WAYLAND BOARD OF HEALTH LOCAL UPGRADE APPROVAL and/or VARIANCE REQUEST FORM

Location of Property: 264 Old Connecticut Path Wayland, MA

**RE: Approval of Hydrogeological Evaluation Report
Wayland High School, 264 Old Connecticut Path, Wayland, Massachusetts
Transmittal Number: X231260**

Figure No. F.1
**PROPOSED GROUNDWATER
 MONITORING PLAN**

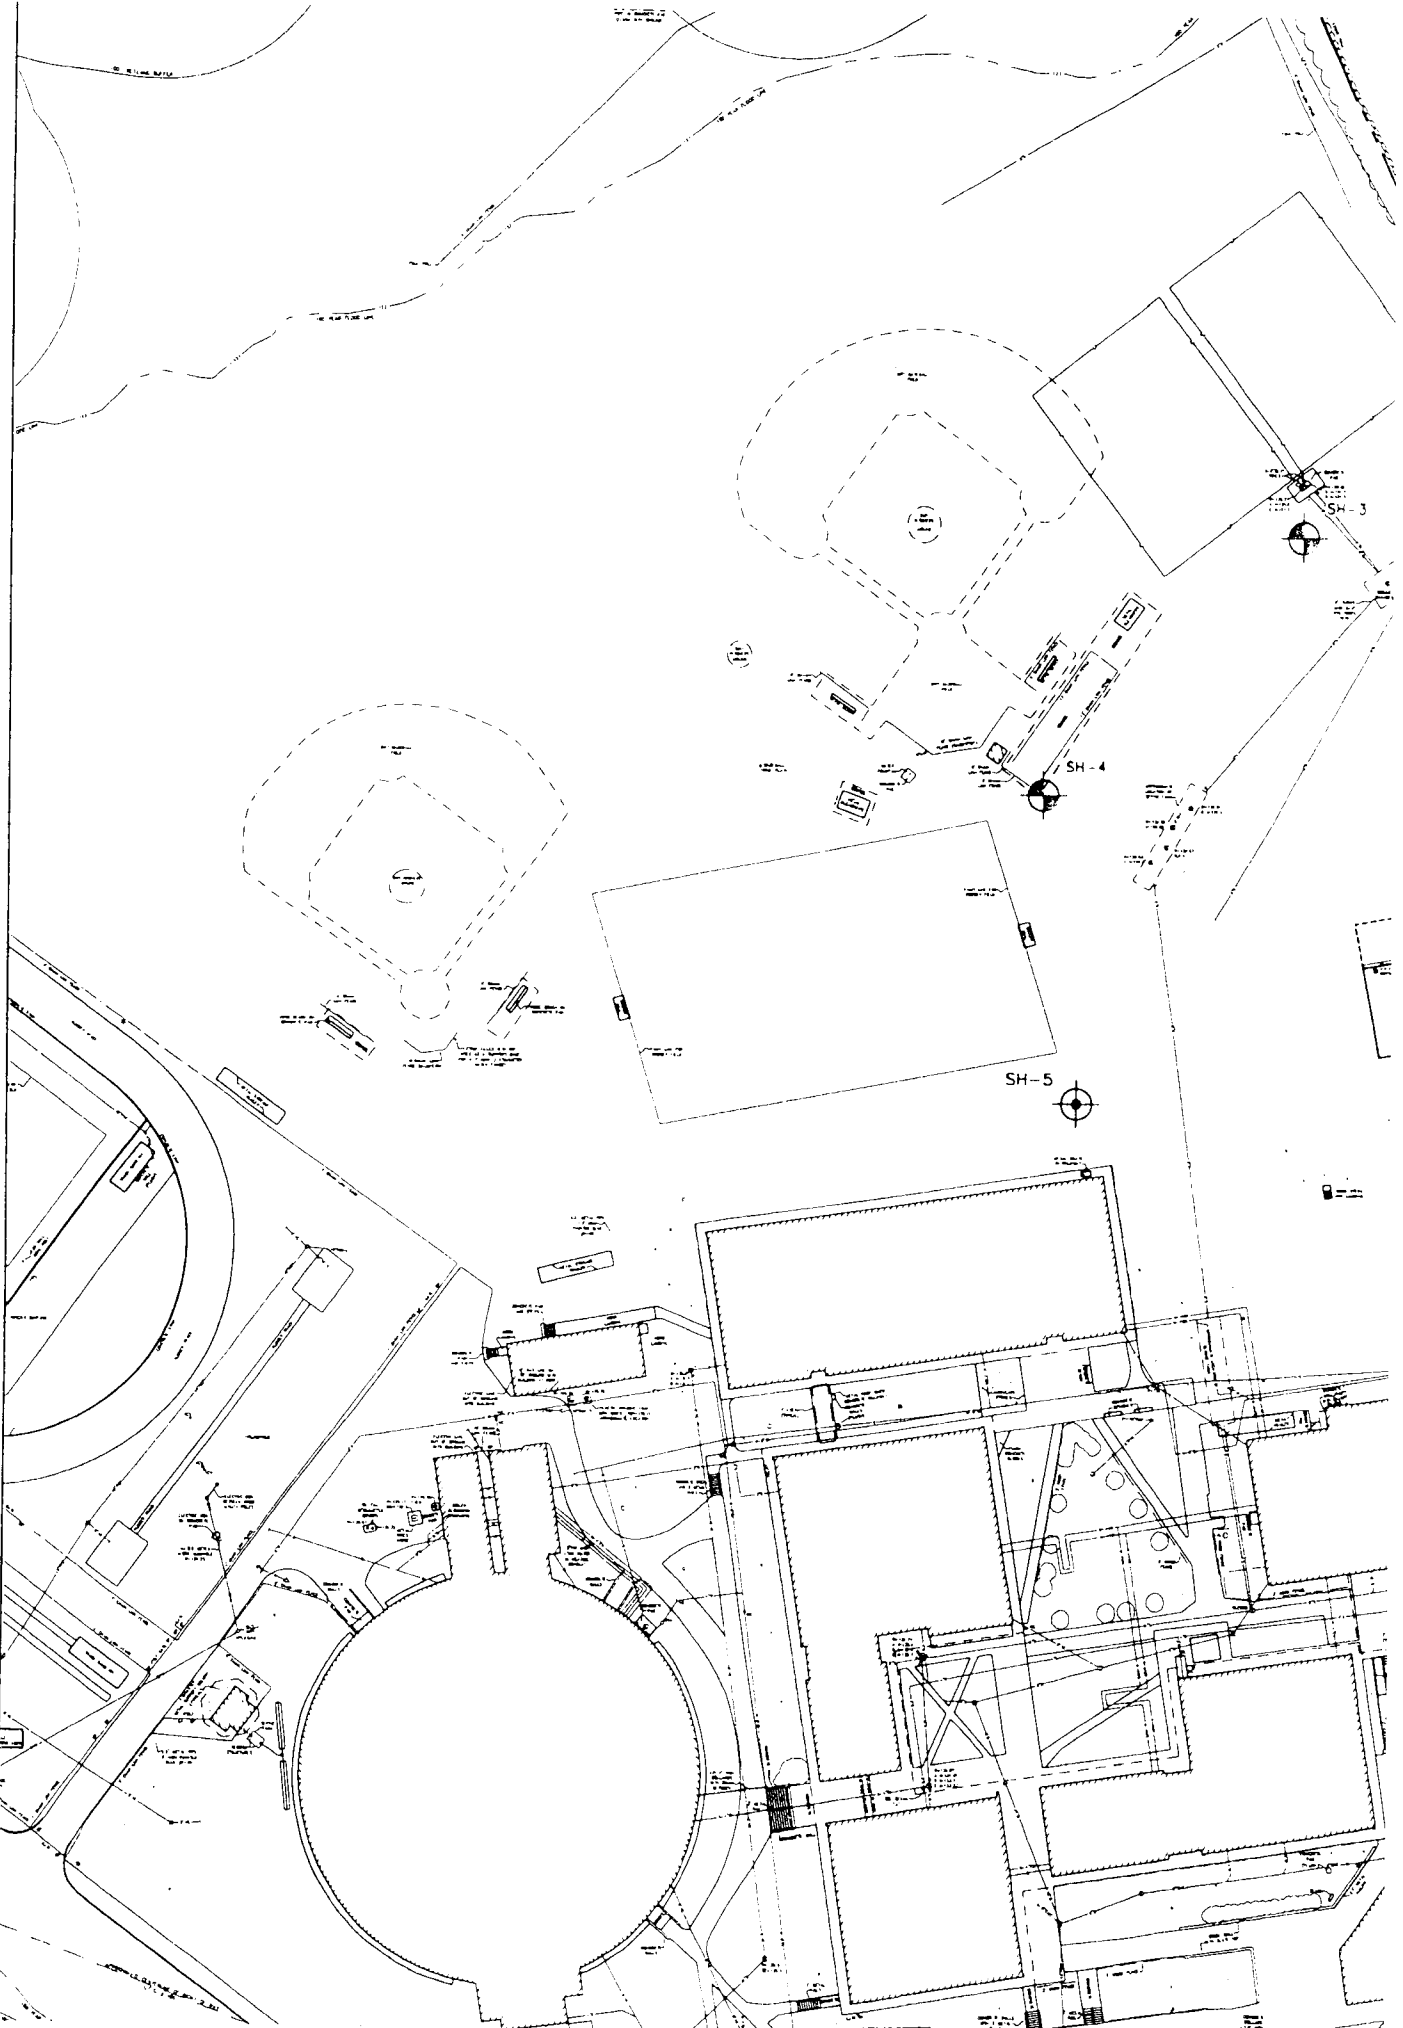
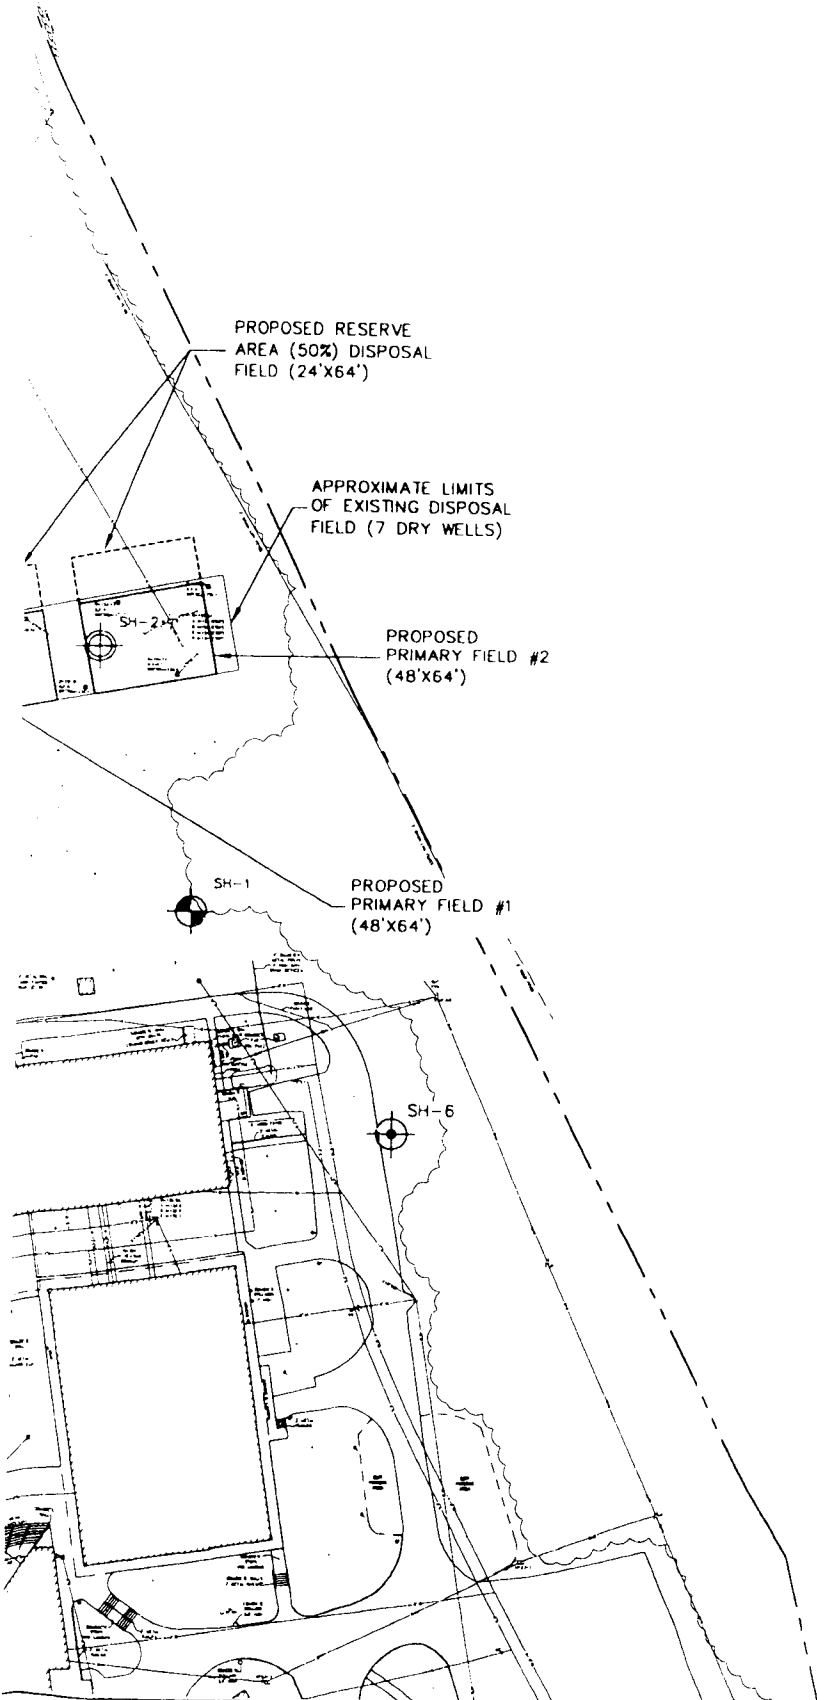
On January 14, 2010, SHA submitted a revised Groundwater Monitoring Plan to MassDEP that outlines procedures for the long-term monitoring of groundwater quality in the vicinity of the proposed soil absorption system. The plan proposes a monitoring well network that consists of five monitoring wells; three existing wells (SH-1, SH-3 and SH-4) and two proposed wells (SH-5 and SH-6). Monitoring wells SH-1 and SH-6 will be upgradient/crossgradient wells capable of assessing ambient groundwater conditions at the site. Monitoring wells SH-3, SH-4 and SH-5 are downgradient of the proposed discharge site.

8. MassDEP approves the monitoring well locations proposed in the revised Groundwater Monitoring Plan. The proposed well locations and the approved monitoring plan will be referenced in the Groundwater Discharge Permit when issued. MassDEP recognizes that proposed locations are somewhat dependent upon final site development (e.g. building and road placement) and may require modification, however changes must be submitted to this office for approval prior to well installation. Final monitoring wells must be installed and sampled for all groundwater quality parameters listed in the issued permit no later than 90 days prior to startup of the wastewater treatment plant and discharge to the SAS.
